**AERONAUTICAL CHARTING FORUM
Instrument Procedures Group
Meeting 09-01 - April 29-30, 2009**

RECOMMENDATION DOCUMENT

FAA Control # 09-01-213

Subject: Guidance & Charting for TERPS Chg 21 Circling Approaches

Current procedure profile view:

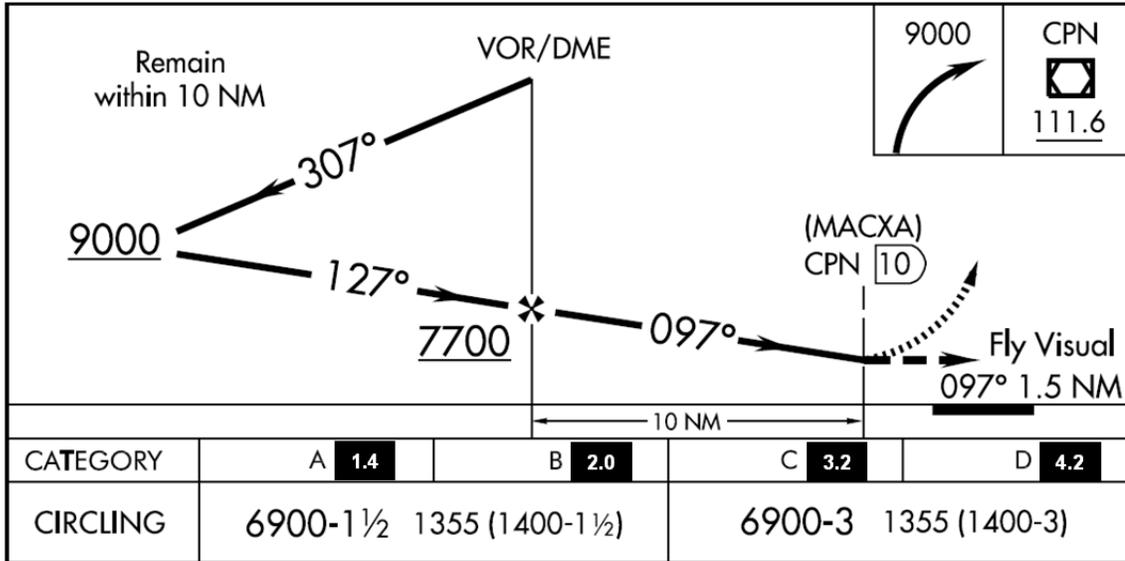
One possible option is to add an ICON that identifies the extent of the circling protected airspace afforded at the CMDA. This ICON would be placed in the profile view, next to the Approach Category letter and would indicate the CAR radius used to define the protected airspace. An example of the use of this ICON is illustrated on the examples below for the Butte/Bert Mooney Airport, Butte MT VOR or GPS-B approach:

The icon next to each approach category depicts the TERPS 21 CAR that defined the protected circling airspace. This provides the pilot with the information necessary pre-plan the circling maneuver so as to remain within protected airspace and locate a descent point that best results in a normal, stabilized approach. The type and nature of the ICON is left to the discretion of NACO and the commercial charting agencies.

Fig 1

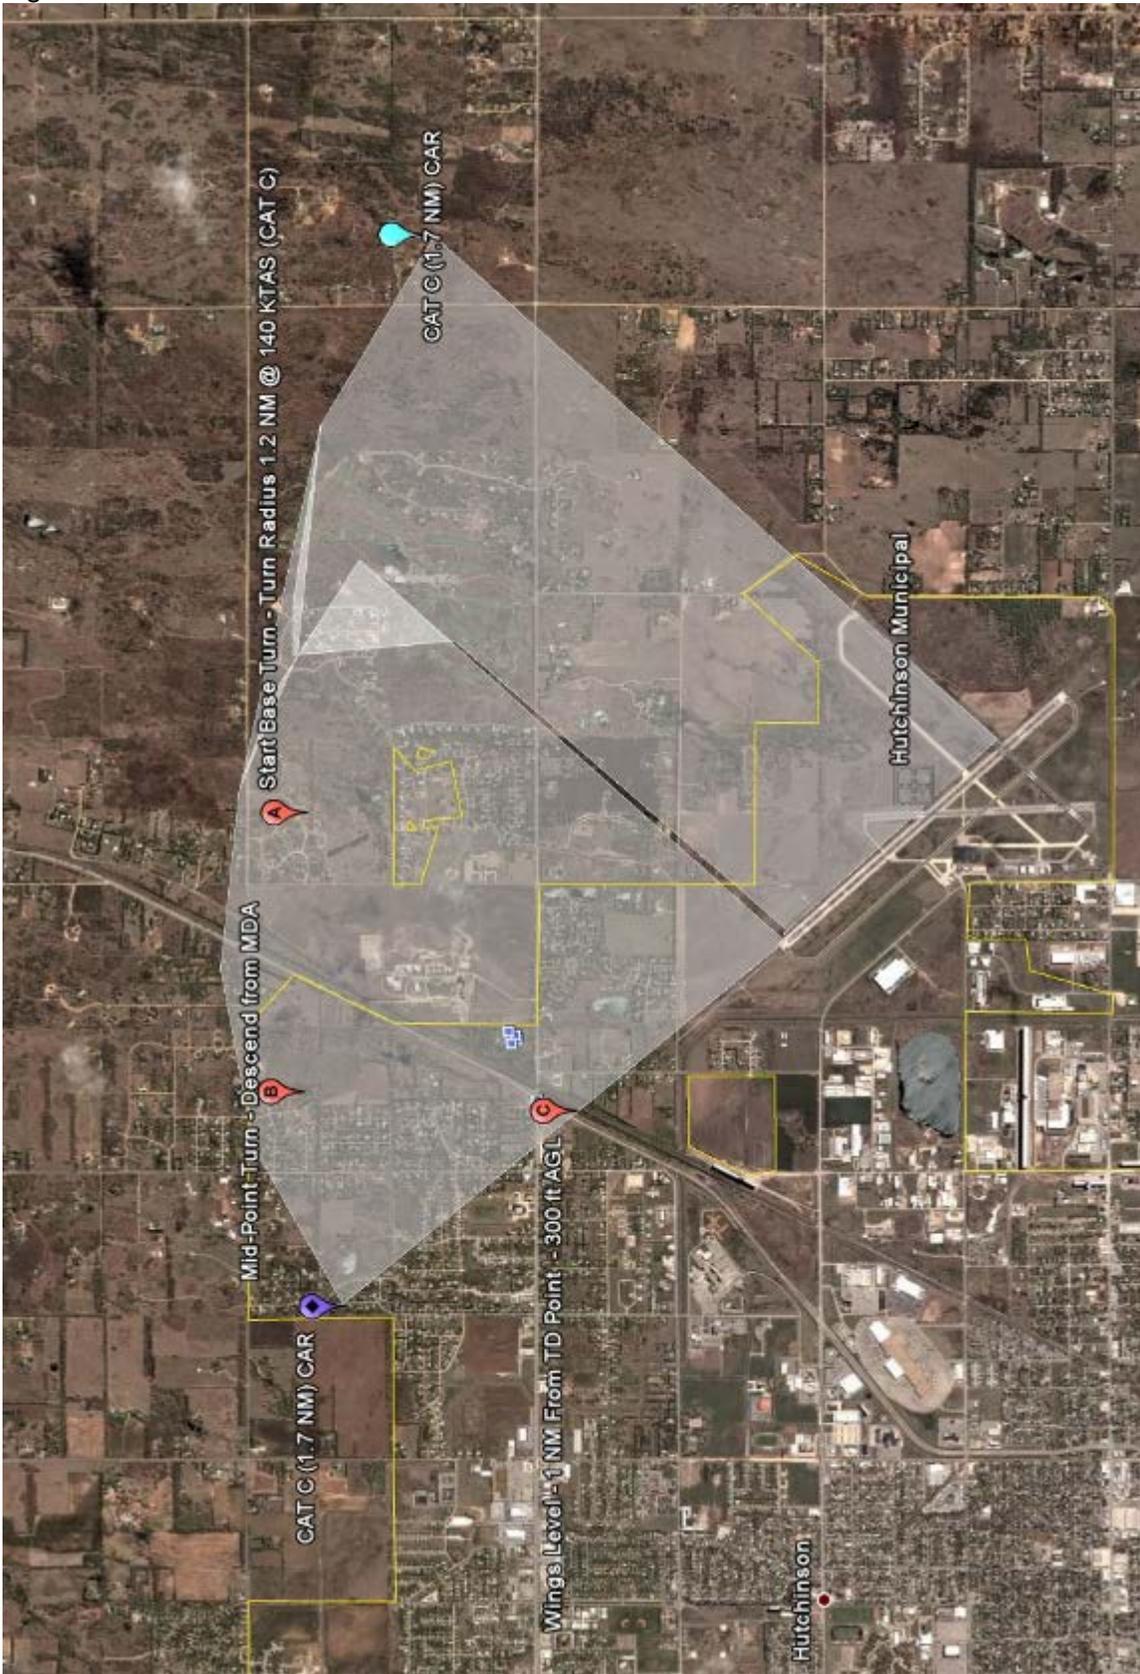
Fig 1 illustrates a nominal circle-to-land approach from a typical CAT C HAA of about 600 ft. In order to arrive at "in-slot" position on the landing runway, the turn radius resulting from the 140 KIAS CAT C speed limit takes the aircraft nearly to the edge of, but still within the CAT C circling protected airspace. The descent from MDA may begin approximately midway through the turn from base to final so as to arrive at the "in slot" position at the correct height. Even with an HAA approaching 1,200 ft, a descent beginning abeam the touchdown point will allow a normal stabilized descent to arrive at "in-slot" position at the correct height above the runway.

However, when the HAA exceeds 1,200 ft, the ability to conduct a stabilized approach becomes problematic for the pilot. When the HAA exceeds 1,200 ft, the descent must be commenced earlier in the circling maneuver, which is often impractical based on the aircraft's position relative to the landing runway. The only other option remaining to the pilot is to use a higher than normal descent rates to complete the descent. To remain within the pre-TERPS 21 CAT C circling protected airspace when the HAA exceeds 1500 ft, a descent gradient in excess of 400'/NM (1000 FPM) is necessary when descending from the abeam touchdown position so as to arrive at the "in-slot" position at the correct height. While the use of CAT D minimums, when

available, allow for slightly more maneuvering room (0.6 NM), the amount is insufficient to provide the necessary maneuvering airspace to manage a stabilized descent as the HAA increases above 1,500 ft.
